# UNITED STATES PATENT AND TRADEMARK OFFICE

APPLICATION NO.	FILING DATE	FIRST NAMED INVENTOR	ATTORNEY DOCKET NO.	CONFIRMATION NO.
10/539,176	06/16/2005	Teruaki Fujinaga	050036	2248

## Office Action Summary

## **DETAILED ACTION**

Figure 1: Figures 6A and 6B of Hazelton et al.

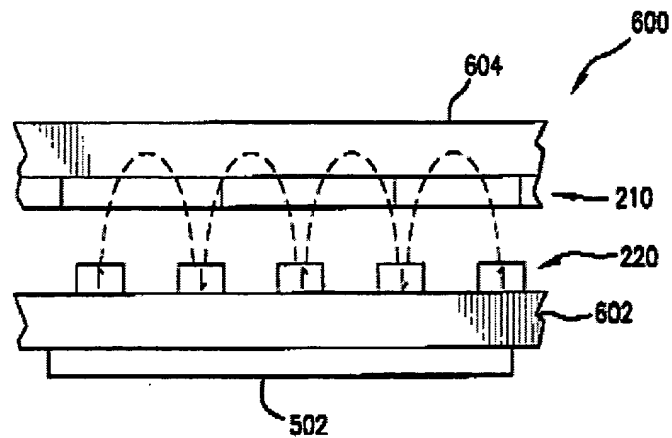
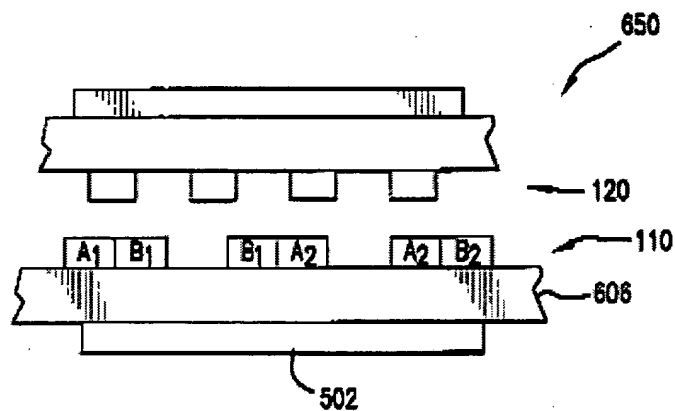
2. Claim 1,2,4-6,8-11 rejected under 35 U.S.C. 102(b) as being anticipated by Hazelton et al. (6,208,045).
3. Regarding claim 1, please see column 3 (lines 1-8, 30-41) and figures 6A and 6B as shown below.

Figures 6A and 6B show positioning devices 600 and 650; magnet arrays 220 and 120; support members 602 and 606; coil arrays 210 and wafer 502. The position devices have a moving part with coils or magnets, and a fixed part with magnets or coils, respectively. The written description of the devices can be found in column 3 (lines 1-8 and 30-41).

8. Regarding claim 8, Hazelton et al. also teach coils mounted on fixed part in column 3 (lines 1-3) and figures 6A and 6B mentioned earlier.

Figure 2: Figure 1A of Hazelton et al.

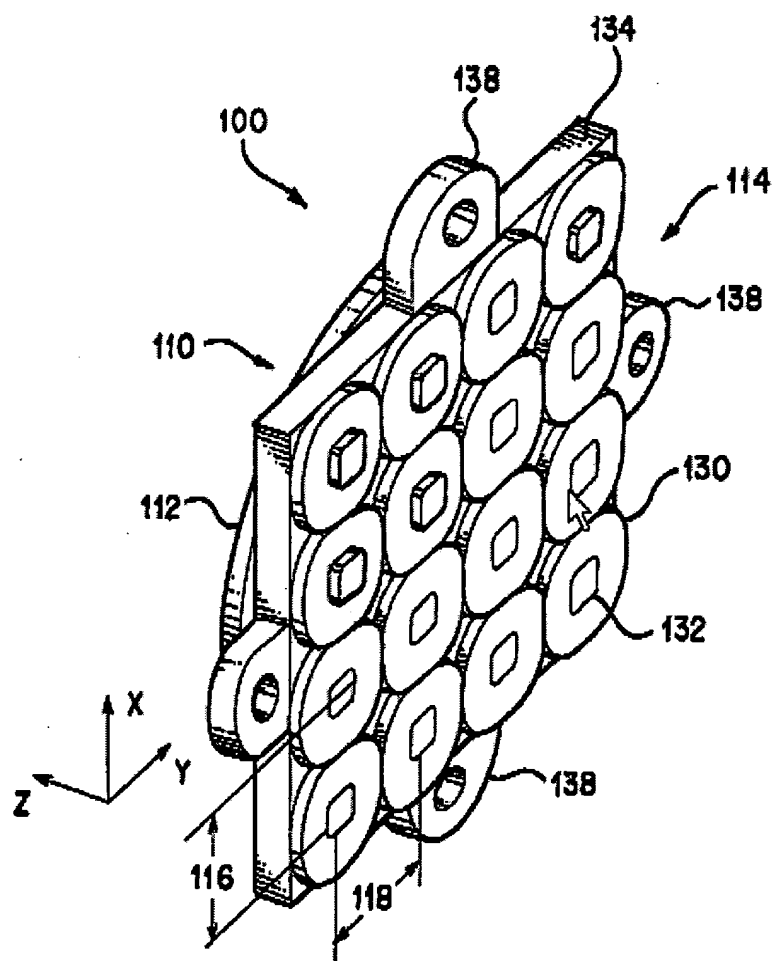
4. In regard to claim 2, Hazelton et al. disclose figure 1A, shown below. With 132 being a post where the coil 130 is wrapped around, the coil has to be wound in a parallel fashion with respect to the surface of the permanent magnet.

6. Regarding claim 5, Hazelton et al. disclose in column 5 (lines 40-44) a backing panel 134 of the above figure 1A that "may comprise a magnetically permeable material, such as iron". This serves to increase the permanent magnetic flux through the coils and boost performance.

10. Regarding claim 10, in column 3 (lines 30-41) Hazelton teaches that the support member can be moved in at least three degrees of freedom. Also, the coil array does consist of a plurality of coils, as can be seen in figure 1A.

11. Regarding claim 11, Hazelton et al. discloses rotation motion about the Z direction in column 7 (lines 15-22) as well as the three degrees of freedom movement in column 3 (lines 30-41). As mentioned before, the coil array does consist of a plurality of coils, as shown in figure 1A.

Figure 3: Figure 1A and 1B of Wasson et al.

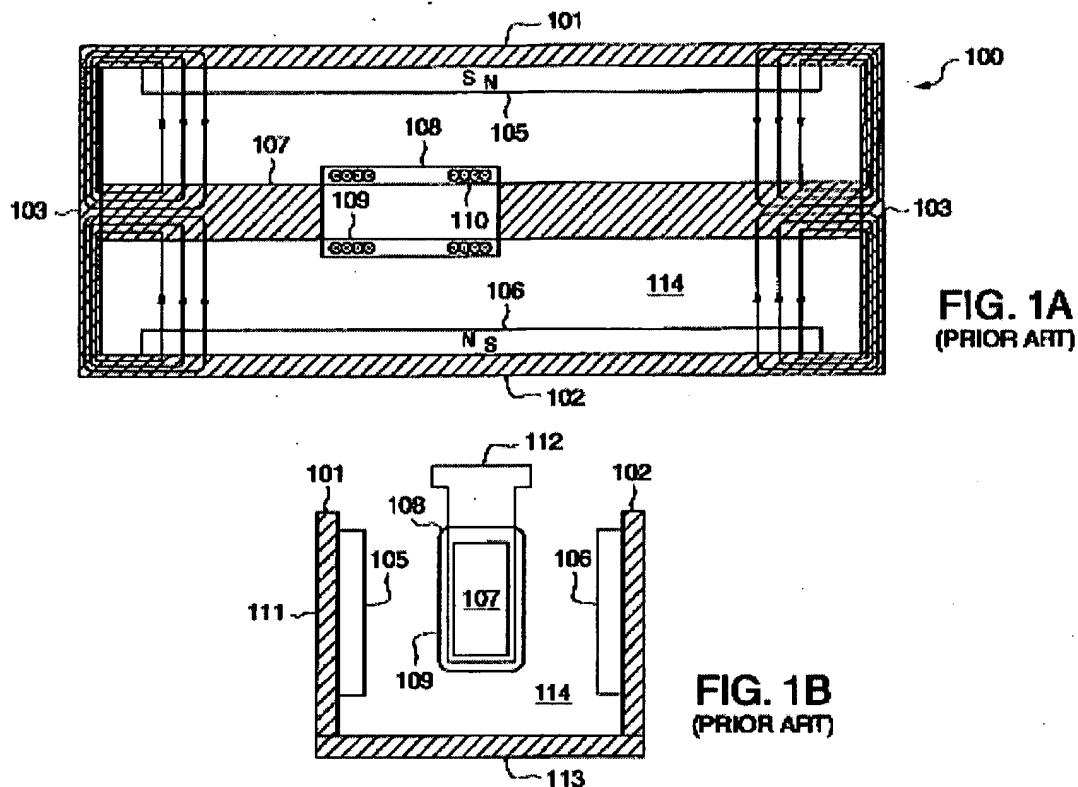
13. Claim 3 rejected under 35 U.S.C. 103(a) as being unpatentable over Hazelton et al. as applied to claim 3 above, and further in view of Wasson et al. (6,163,091). Hazelton et al. fails to teach the idea of having the coil wound perpendicular to the surface of the permanent magnet but Wasson et al. does. Figure 1A and 1B as shown below, and column 2 (lines 1-13). Wasson et al. disclose that a coil wound in a perpendicular or parallel manner would basically have the same effect. "In either case, the principle that a current applied to the coils will cause the coils...to experience a force and, therefore, to move relative to the magnets, applies."
